Featured Products Bulletin

INDUCTIVE COMPONENTS

Data Sheet Correction to Solder Terminal Dimension for SRP1265(A) Shielded Power Inductor Series

Figure 1

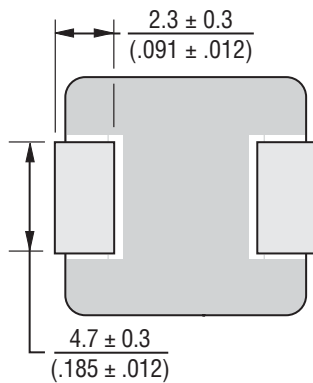
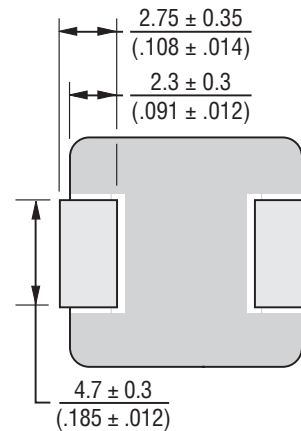
Recently, an error has been discovered in the solder terminal dimension of the [Model SRP1265\(A\)](#) data sheet drawings. The erroneous dimension (*Figure 1*) has been corrected (*Figure 2*).

The solder terminals of these two series have been manufactured to the *Figure 2* dimension since the inception of these inductors. This data sheet correction for Model SRP1265(A) has no impact to the form, fit, function and quality of the components.
